## **Declaration Letter**

Fengmi (Beijing) Technology Co., Ltd.

## Updated power board:

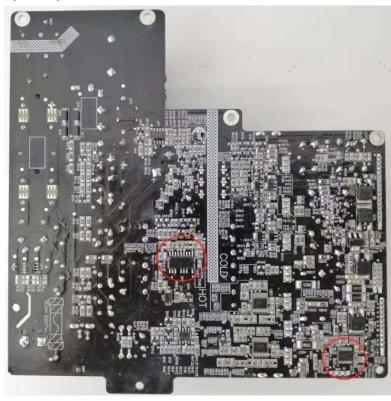
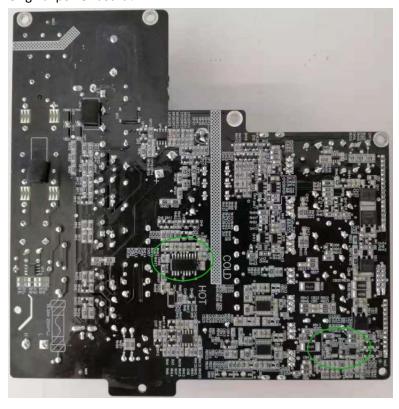
| Difference items   | Previous power board   | Updated power board   |  |  |
| Control chip (UH1) | Pin 4 connected with CH57 0.01uf capacitor Pin 8 connected with $100 \text{k}\Omega$ RH113 resistance.                     | Pin 4 connected with RH115 $100k\Omega$ resistance. Pin 8 connected with CH37 $0.1uF$ capacitor.  |  |  |
| Components         | 2pcs digital potentiometer UB1 &UB4  | MCU chip UM1  |  |  |
